SOUTH ELEVATION
 ST. TAMMANY PARISH ADMIN. COMPLEX
 520 OLD SPANISH TRAIL
 SLIDELL, LOUISIANA

RENOVATE OFFICE BUILDING
DAMMON ENGINEERING, INC.
 1095 FLORIDA AVENUE 985-649-5832 SLIDELL, LA. 70458
 DAMMONENGINEERING.COM

A-8

CONTRACT SET- 10/10/07

SOUTH ELEVATION
 SCALE: 3/16" = 1'-0"

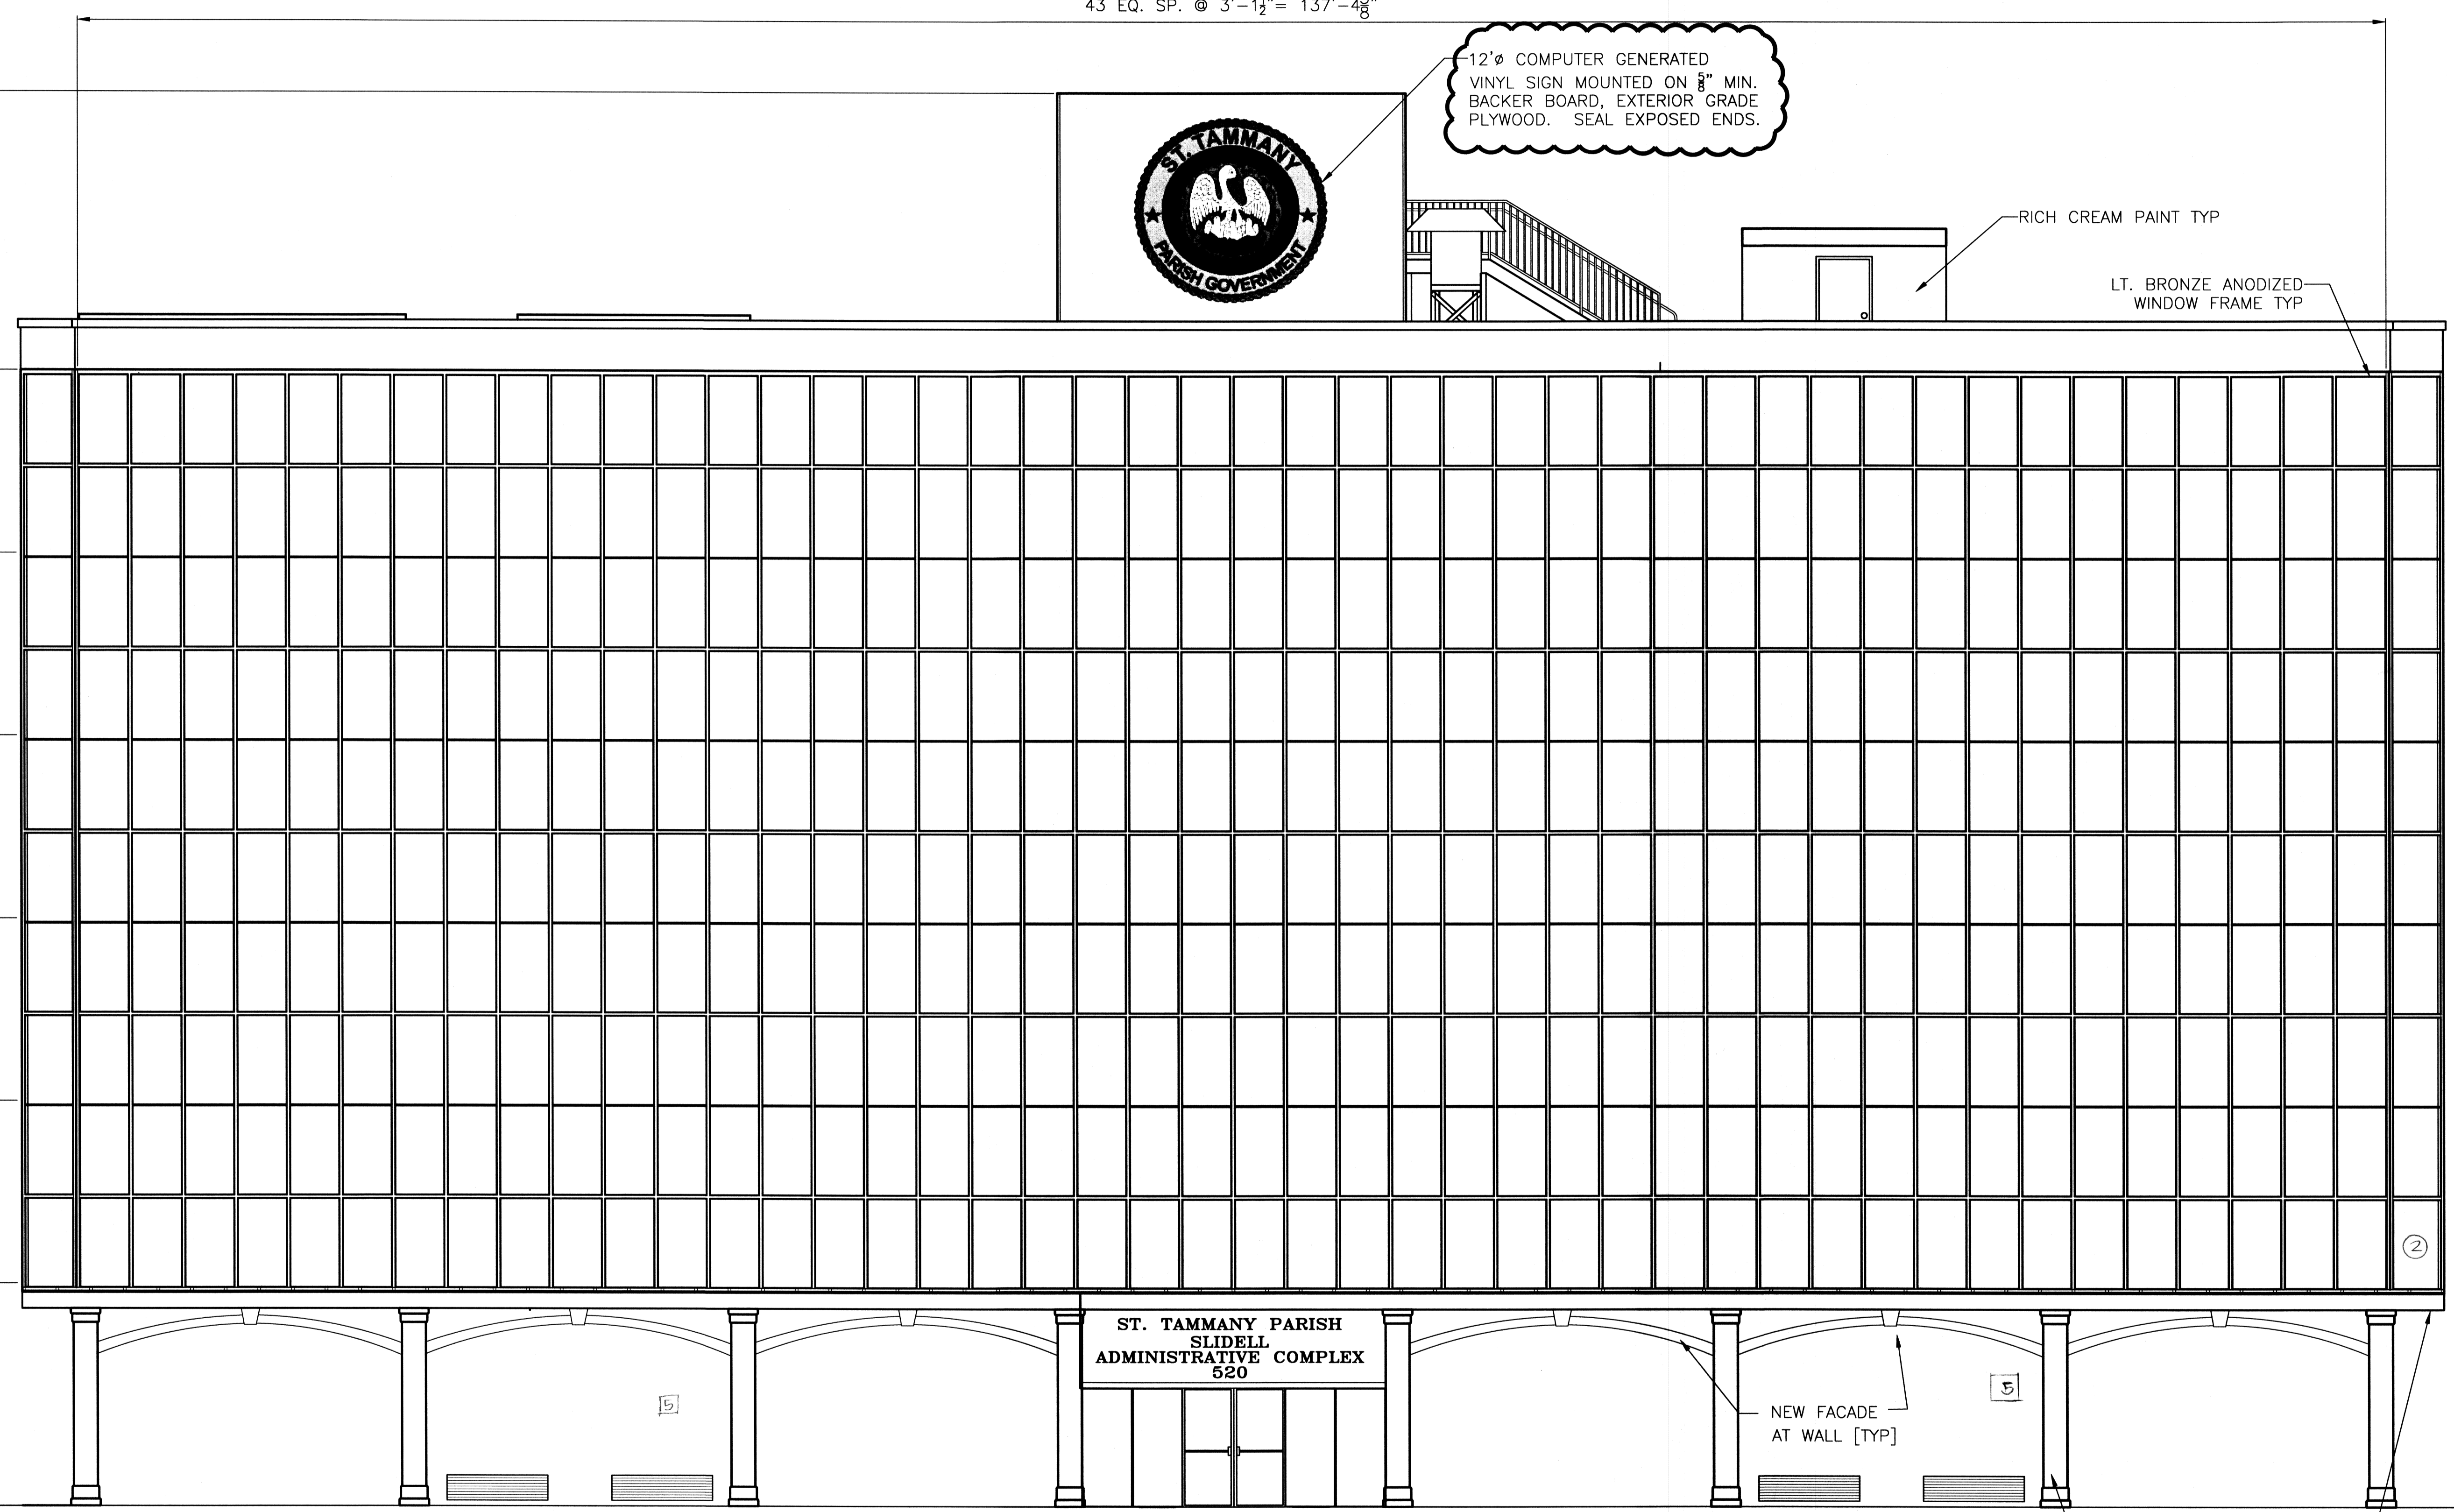
NEW FACADE
 AT WALL [TYP]

NEW DECORATIVE COLUMNS
 & BEAMS
